# Land Use Policy Framework

Working Group Feedback – September 19, 2024

(Mary, Ali, Sharon)

# Central SMART Station Location

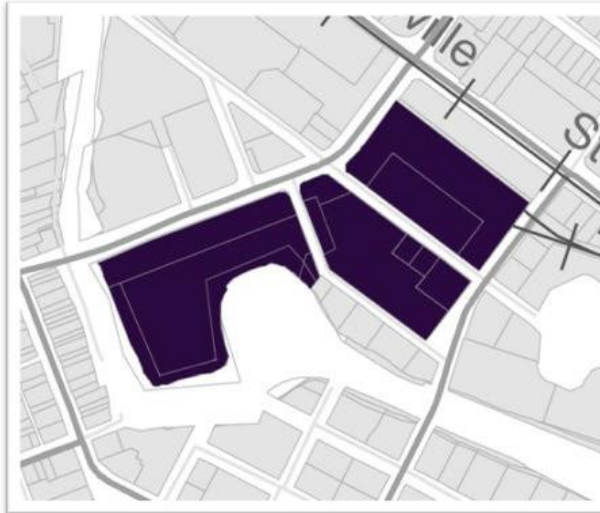
**WG Feedback:** Support Station Mixed Use / T8 (new) at the station feathering to lower heights at the river. Density minimums are needed to avoid building something that wastes valuable station adjacent space.

(Green boxed area is greenfield. Balance is River Plaza.)

# River Park

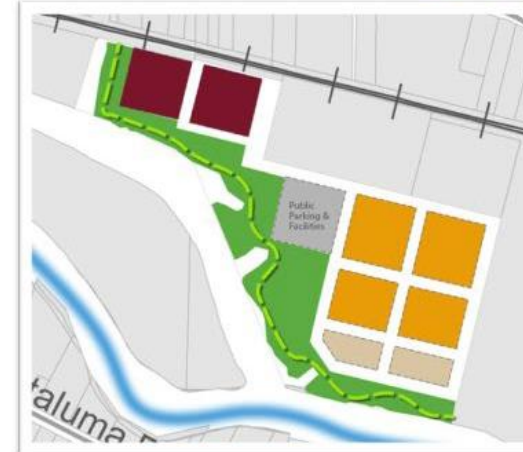
**WG Feedback:** Maximize equity access to the River with dense housing and some public parking. Modified Alt 2: Downtown Mixed Use / MU2 (4 stories), Urban Corridor Mixed Use / T5.5 (5 stories). Intensify use with Oyster Cove as starting point., feathering up from Oyster Cove (from 3 stories to 4 stories) and up to 5 stories back from the River.

# Petaluma Blvd No

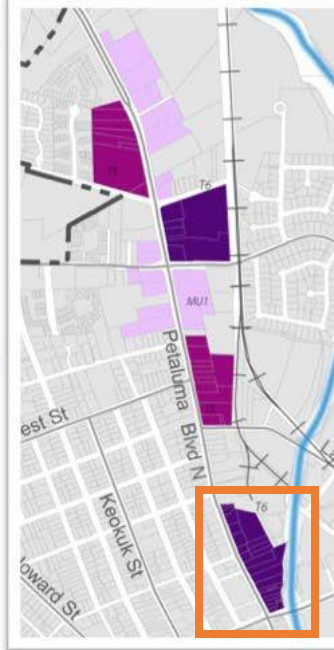
**WG Feedback:** Modified Alt 2, reduce the area abutting Washington to Urban Corridor Mixed Use / T5.5 to minimize sight line disruptions to the River.

# East Washington

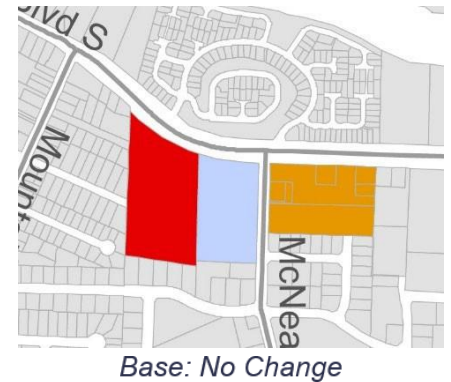
**WG Feedback:** Alt 2, intensification feeds trains and enhanced transit hubs, but intensity may need to be bumped up as we approach the freeway (not pictured here, see notes).

# Potential 15-Minute Activity Center: Casa Grande Center

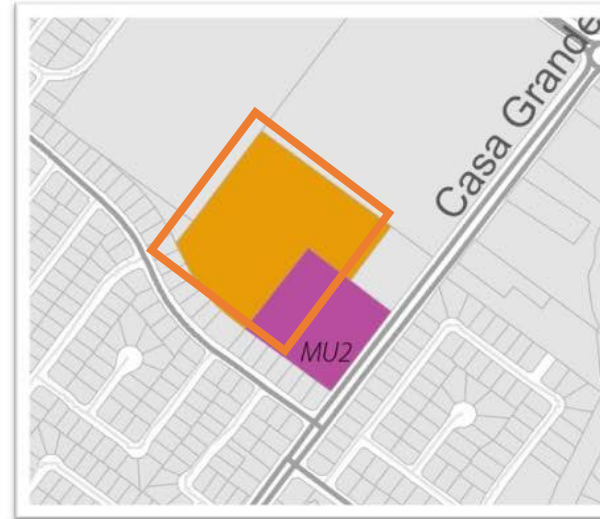
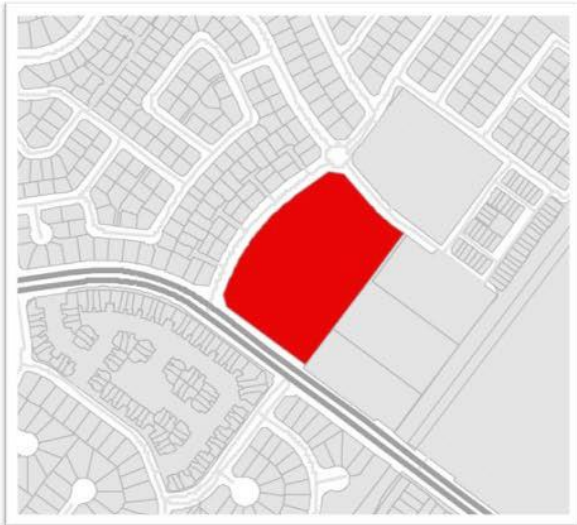
**WG Feedback:** Modified Alt 3, replace the Medium Density Residential (up to 3 stories) with High Density Residential (up to 4 stories).

# Potential 15-Minute Activity Center: Leghorn Marketplace

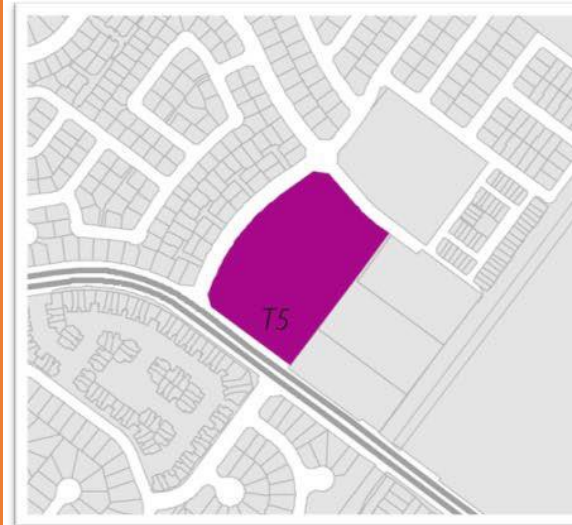
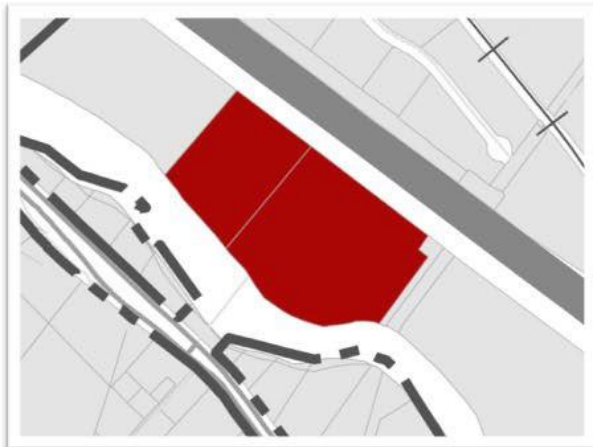
**WG Feedback:** Support intensifying to 4 story, Urban Center Mixed Use / T5 to support small workforce housing and bring in the density needed to support businesses in the area.

# Potential 15-Minute Activity Center: The Outlets

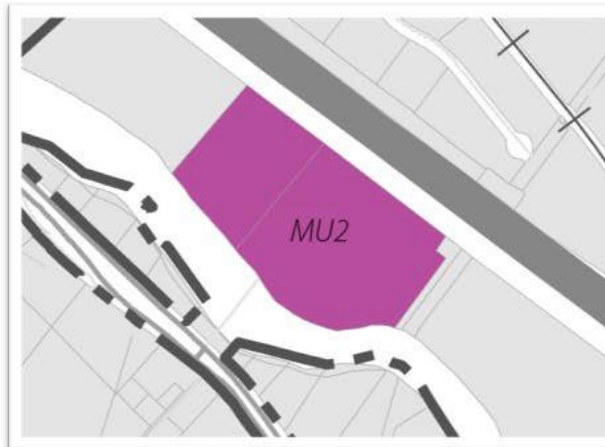
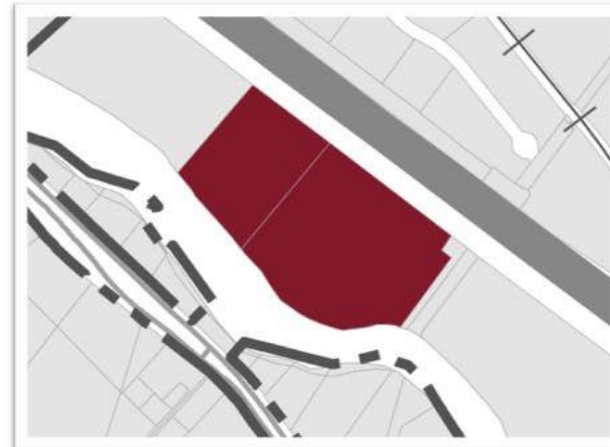
**WG Feedback:** Support Alt 2 because of flooding in this area. We don't support residential uses, we don't want residents to be cut off when the parking lot is inundated (for example).
